Appendix I of RNTPC  
Paper No. A/YL-NSW/331B

APPLICATION FOR PERMISSION  
UNDER SECTION 16 OF  
THE TOWN PLANNING ORDINANCE  
(CAP. 131)

(a) Proposed use(s)/development  
擬議用途/發展擬議臨時商店及服務行業（五金零件銷售）  
Proposed Temporary Shop and Services (Sales of Hardware Accessories)

## Planning Application No. A/YL-NSW/331

**APPENDIX C**  
**PROPOSED DRAINAGE PLAN**

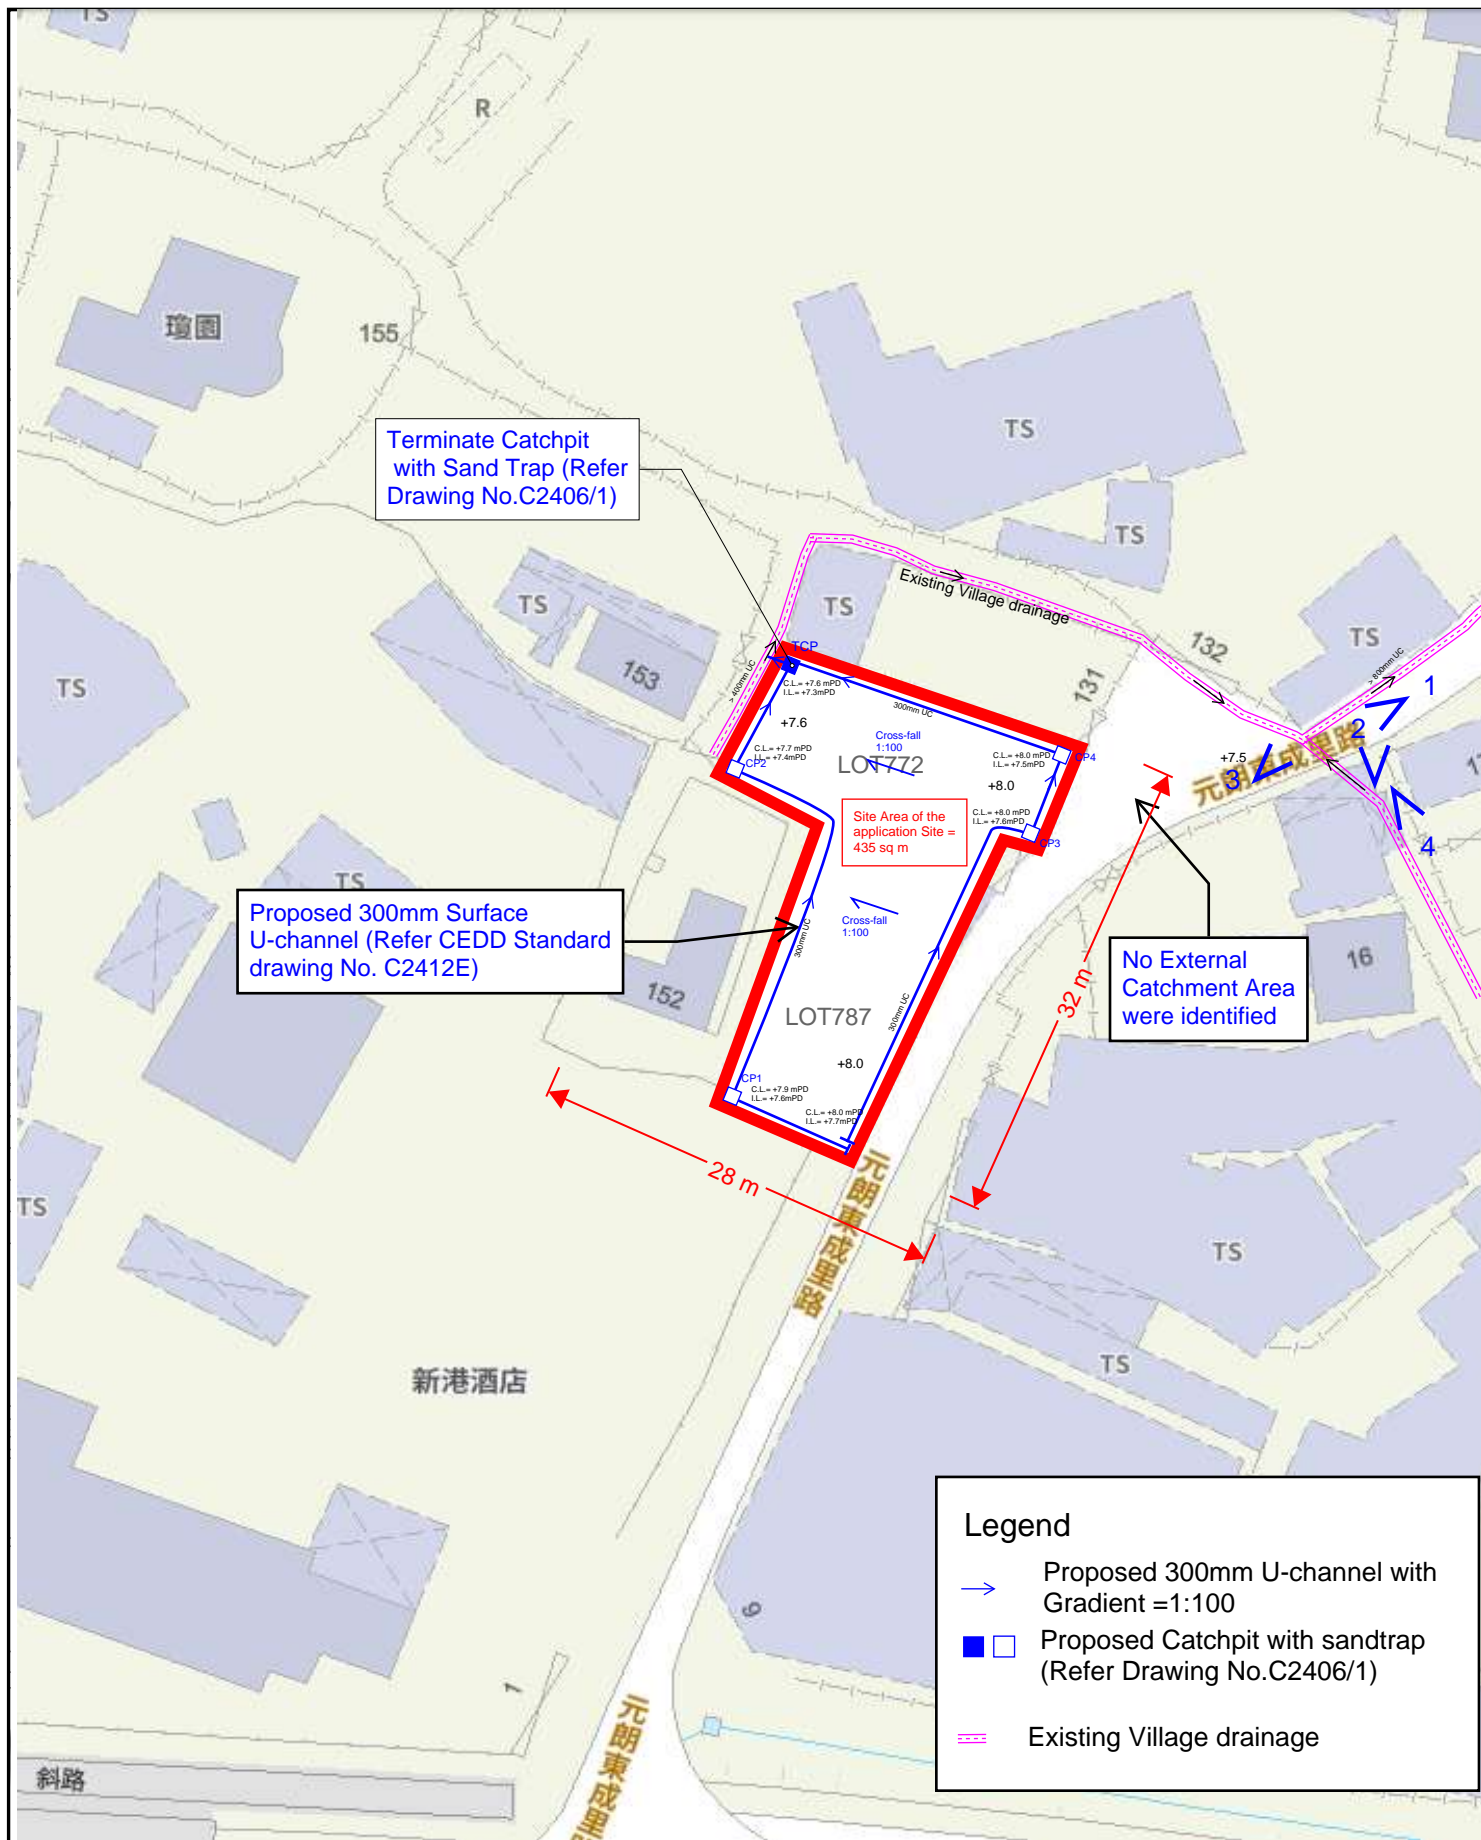
<b>No.</b>	<b>Comments</b>	<b>Response</b>
1.	The submitted drainage proposal does not include most of the essential information such as u- channels gradient, relevant hydraulic calculations, provision/ cover and invert levels of catchpits, cross sections of the site and adjacent areas, u-channel/catchpit standard details, etc.	Noted. Please refer to the captioned Drainage report. The assessment reviews the drainage pipe have the sufficient capacity to cater for the drainage flow from the Application Site.
2.	The applicant is required to submit a revised drainage proposal for vetting. In general, peripheral surface channels shall be provided along the site boundary to collect the surface runoff accrued on the application site and to intercept the overland flow from the adjacent lands.	Noted with thanks. The revised drainage proposal are therewith submitted for your approval.

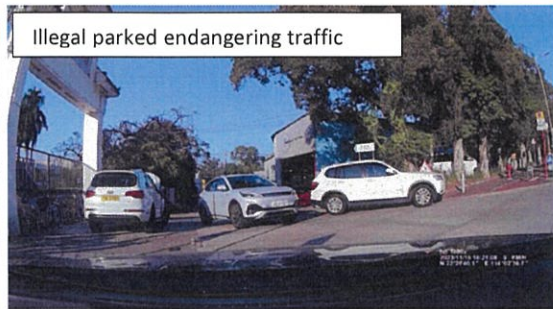
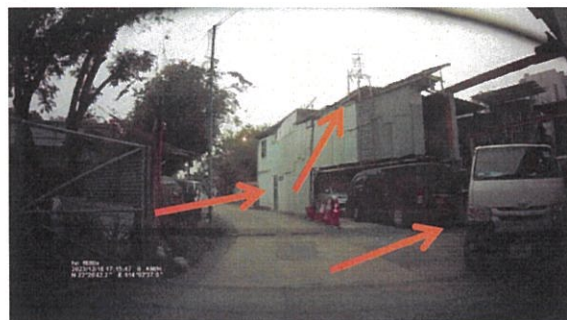
TSL road will illegal parking at the entrance, endangering traffic, pedestrians, cyclists and people.

TPB application site, where cars are parked on the road, endangering incoming and outgoing traffic.

TPB application site, lights are on at 2300 hours, suspected sub-tenant residing at the site and the site is not fully for commercial purpose as said in the application. Also the construction has TV antenna present. The resident exit door is on the side.
